To Reviewer Comment 1

Following are my reply to the comments. The reviewer's comments and questions are in bold, and my reply is in blue and normal text.

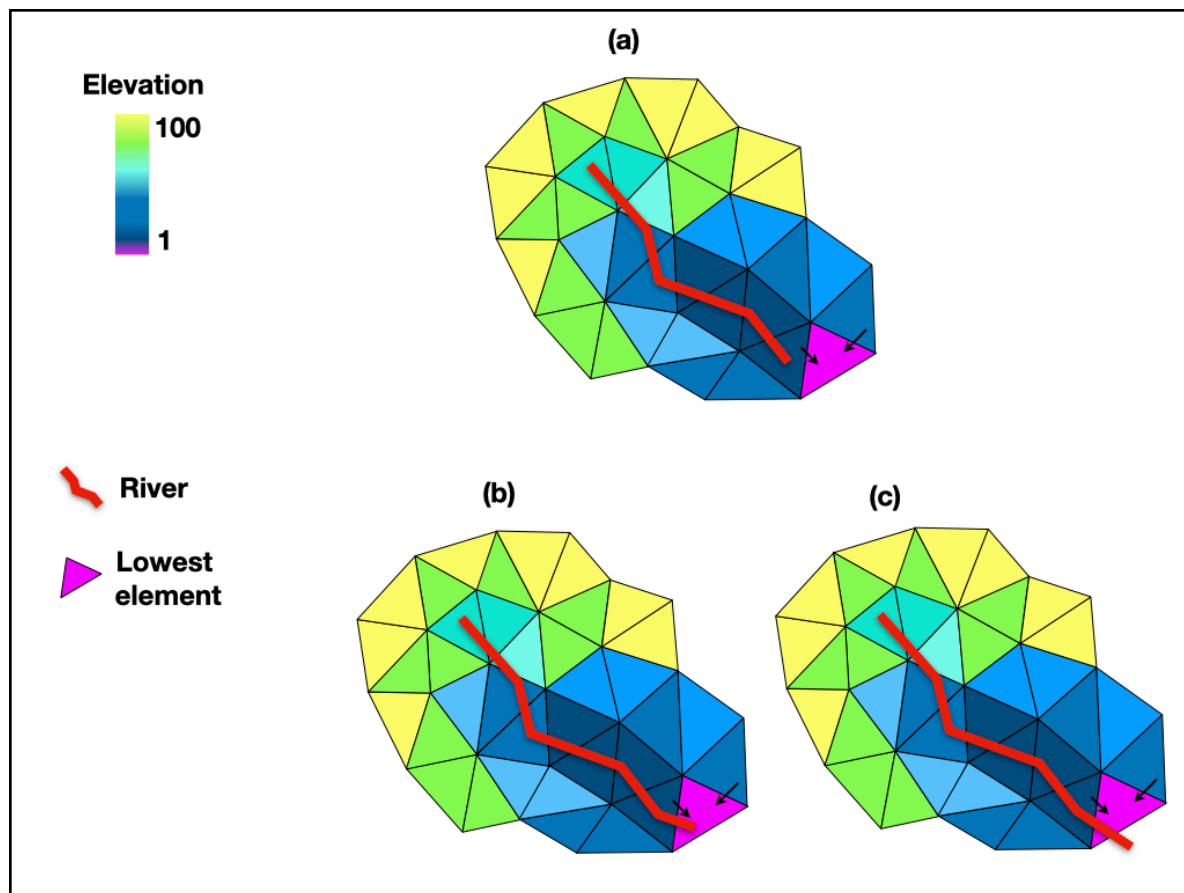
Line 146: Really? I am not sure what you mean by ‘river outlets at the edge of the watershed’?

When we mention that a river outlet must be located at the edge of the watershed, we are referring to the necessity for the river outlet to be positioned in such a way that it facilitates the drainage of water from the

lowest point in the watershed, ensuring there's no artificial accumulation of water. This is the result of data processing.

Subfigure (a): Here, the river outlet is situated within the watershed boundary but does not connect with the lowest element (shown in pink). This configuration leads to water accumulating in the lowest element, creating a pseudo-lake, as water cannot flow into the river or exit the watershed.

Subfigures (b) & (c): In these scenarios, the river outlet is in direct contact with the lowest element. This ensures that water from the lowest element can seamlessly flow into the river, allowing the river to effectively drain water out of the watershed.

The positioning of the river outlet is crucial to prevent unintended water accumulation and to ensure accurate hydrological modeling. We've included a figure in the manuscript to visually represent these conditions, which should provide a clearer understanding of the concept.
